Location:
2380 Tyre Dr

Request
A variance request
to allow an
accessory structure
in the side yard.

Case Manager:
Lauren Coffman,
Associate Planner

Hudson Board of Zoning and Building Appeals	
May 15, 2025	DOCKET 2025-285

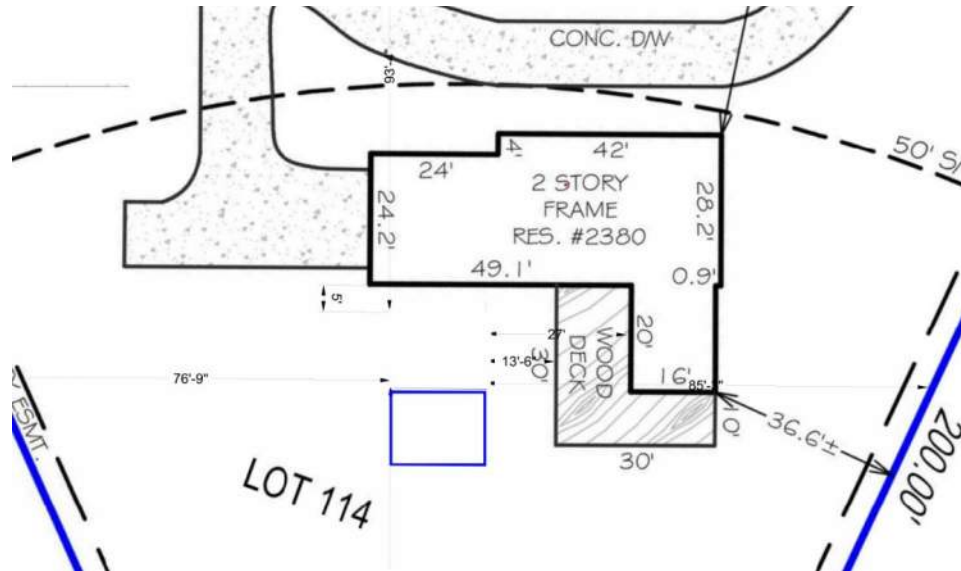
Staff questions why the structure could not be placed farther to the rear of the home as depicted in the following example:

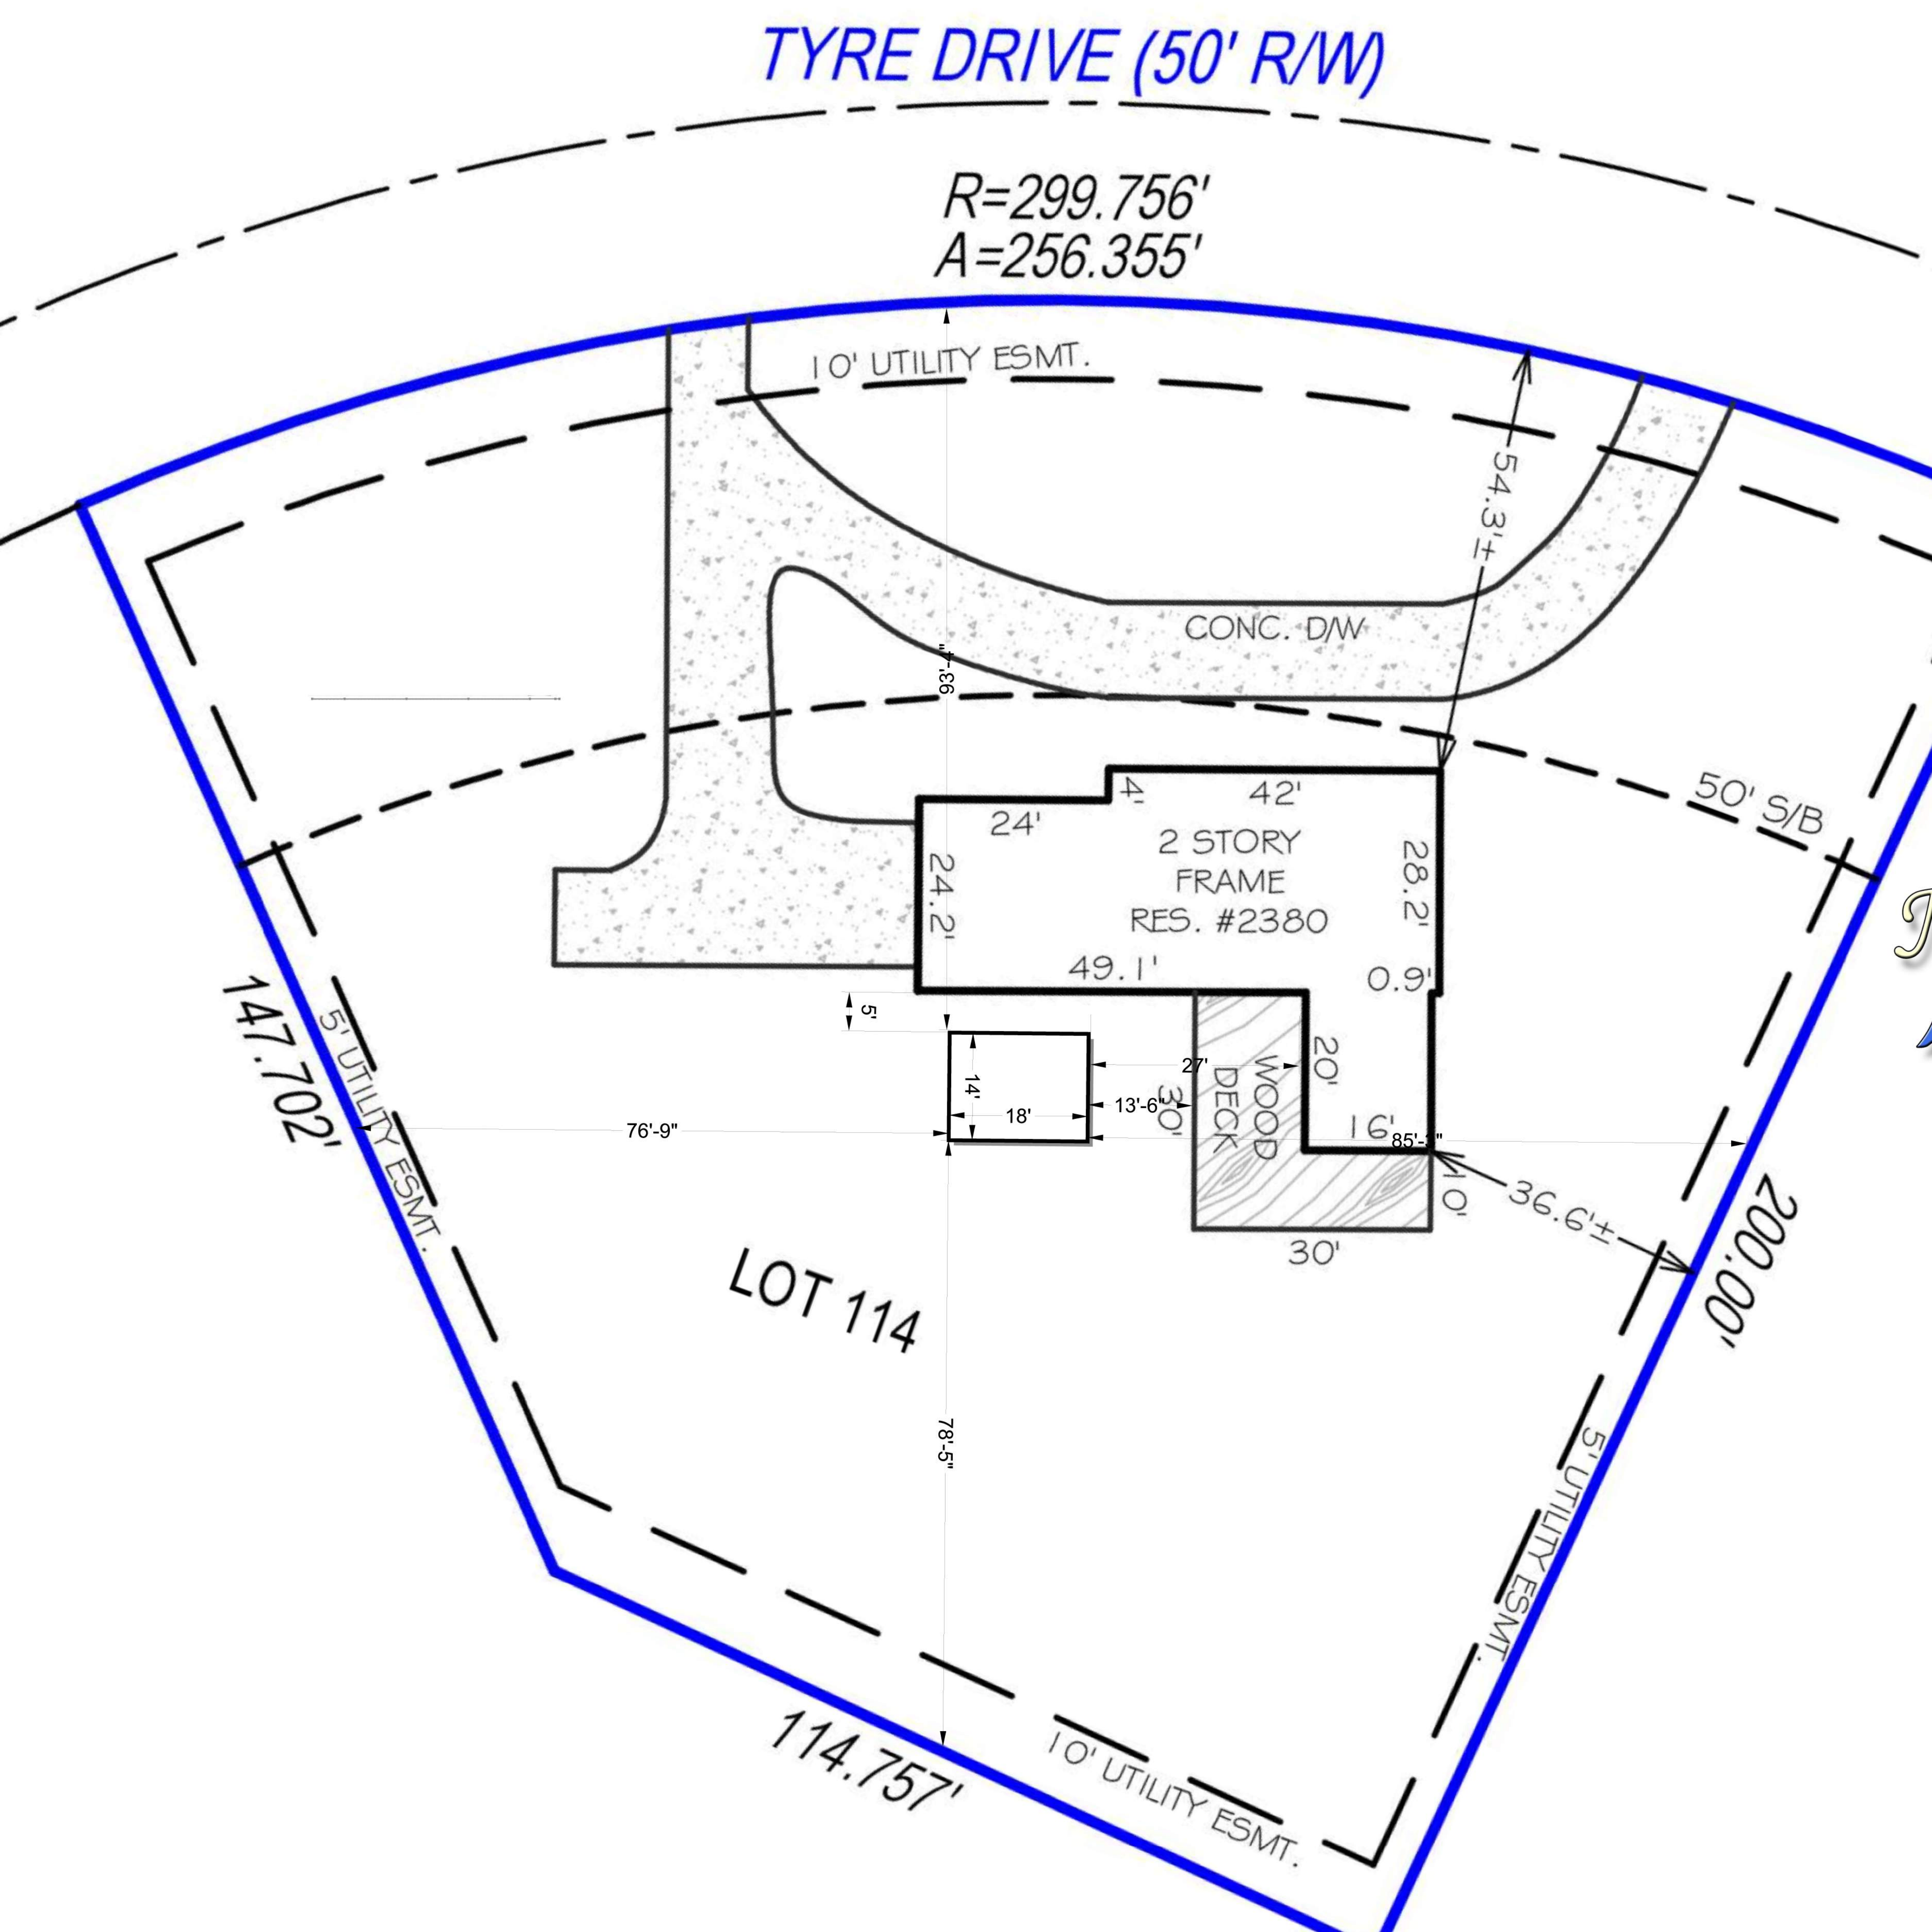
The property in question will yield a reasonable return and there can be beneficial use of the property without the variance as there is sufficient room within the rear yard to construct the accessory structure to meet all Land Development Code requirements.

Staff notes that the requested variance would represent a 100% deviation from the code requirement; however, the structure would only be adjacent to a 16ft x 20ft extension of the home.

- The lot is approximately 0.77 acres
- The proposed structure would have setbacks of approximately 76 feet from the side property line and 93 feet from the front property line.
- While the structure would be located in the side yard per the definition of the code, the structure would be located entirely behind the main mass of the house.
- The design of the structure is open air and would have less of a visual impact than a structure with exterior walls.
